ENDURE ENGINEERING

CLIENT: WHITTENTON BUILDERS
MAIN PROJ. # 25-1-33
SCOPE OF WORK: STRUCTURAL LETTER
ADDRESS: "LONE STAR" PLAN
DATE: 10/17/2025
ENG: CLH

THIS LETTER IS INTENDED SOLELY FOR THE CLIENT LISTED AND ADDRESS. THE PURPOSE OF THIS LETTER IS TO PROVIDE A RECORD OF AN INSPECTION.

S2

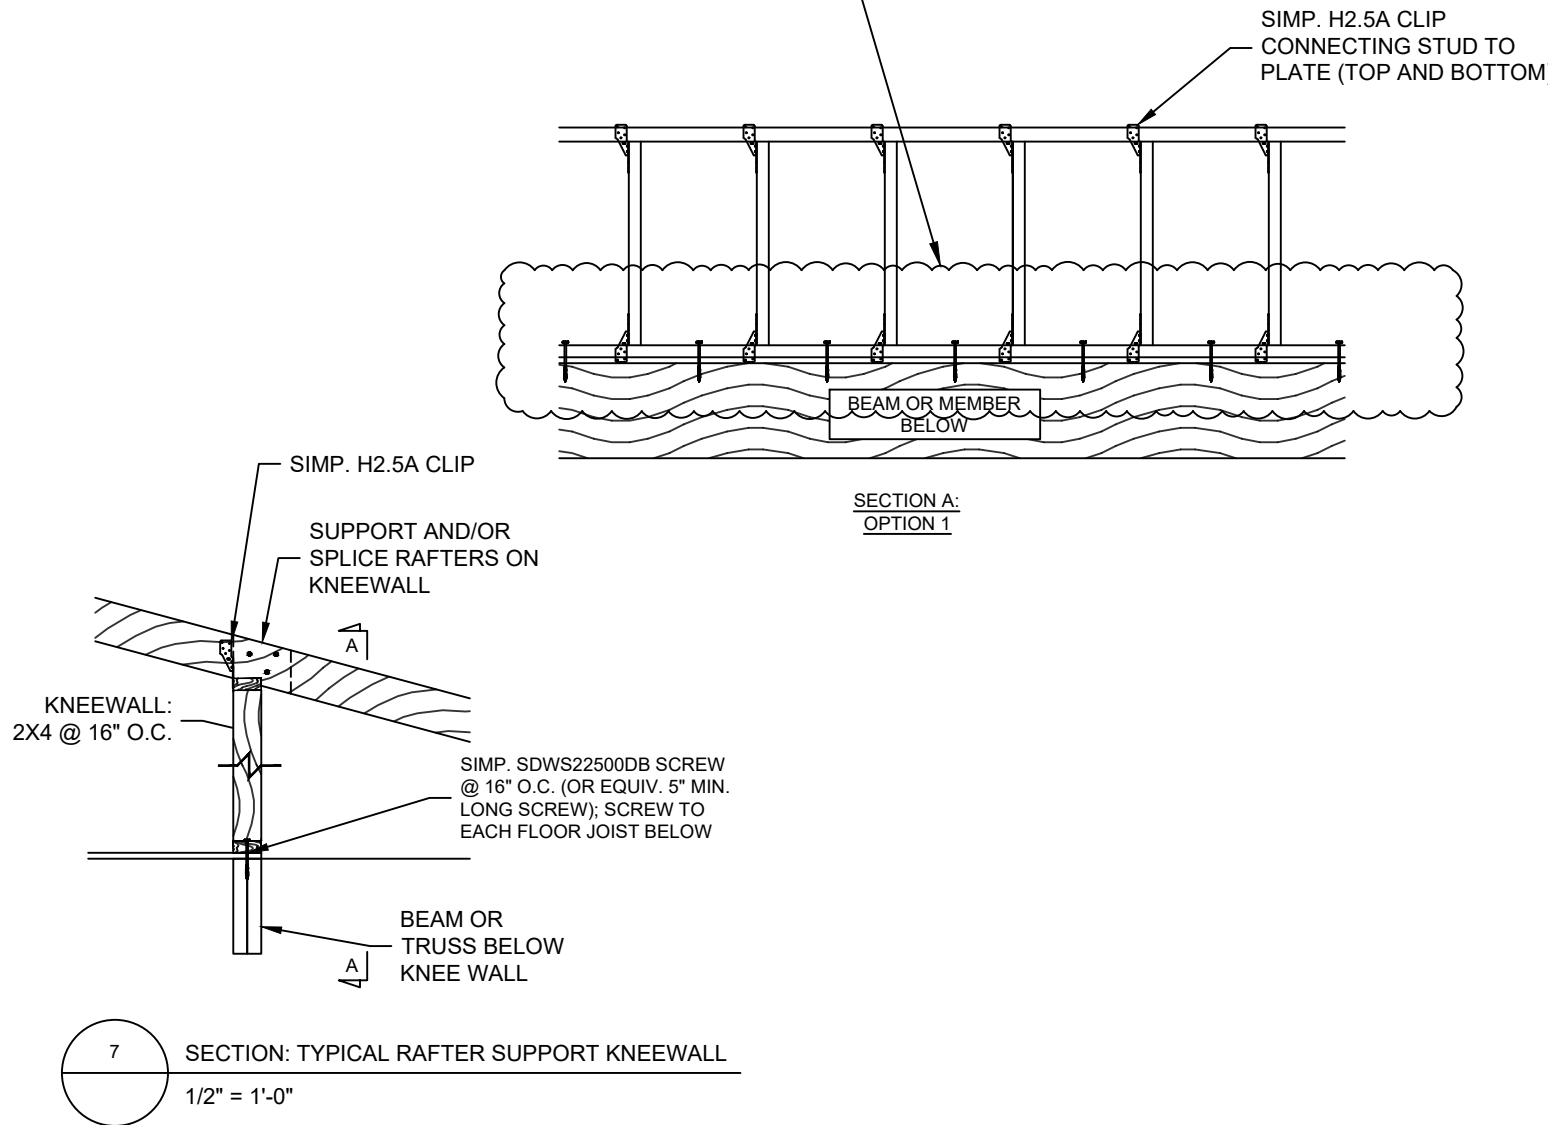
BUILDER NOT REQUIRED TO PUT SIMPSON H2.5A
AT BTM OF KNEEWALL. SHEATHING CONTINUES
DOWN ONTO BEAM / WALL AND NAILED

APPROVED 10-17-2025
